LATEST REVISION DATE 10-13 <i>Norman E. McQuill</i> APPROVED BY BRIDGE ENGINEER		
	STANDARD DESIGN - 40' ROADWAY, 3 SPAN BRIDGES <b>CONTINUOUS CONCRETE SLAB BRIDGES</b> DECEMBER, 2008	
<b>ABUTMENT BACKFILL DETAILS</b> FOR 0° SKEWS	<b>J40-52-06</b>

**ABUTMENT PLAN**

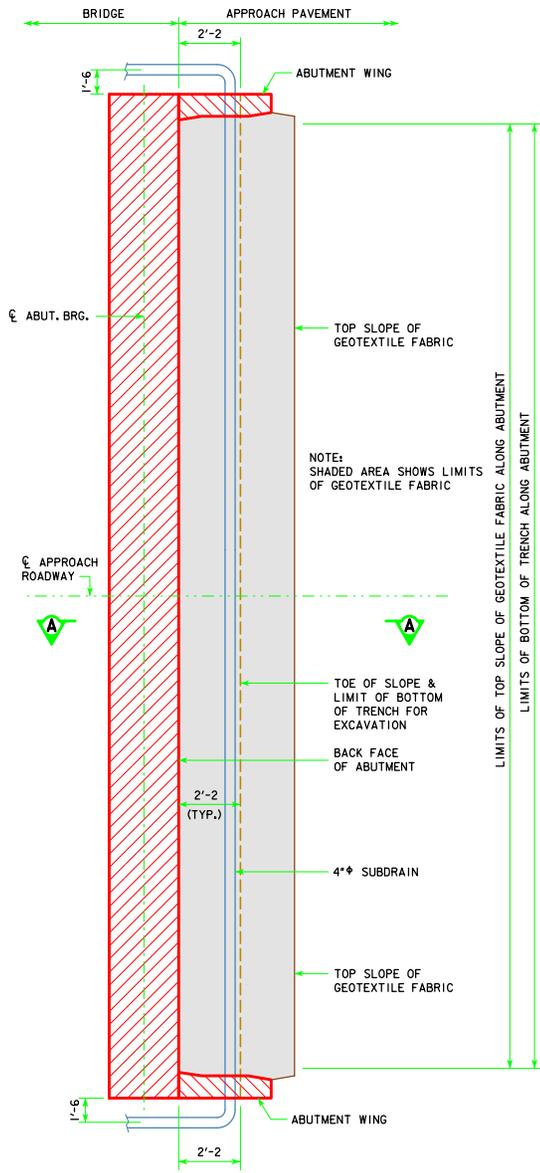
REVISED 10-13 -- EXCAVATION LIMIT ON THE FRONT FACE OF THE ABUTMENT WAS CHANGED TO A 3'-0" LIMIT. THE APPROACH FILL WAS IDENTIFIED AS THE GRADING SURFACE.
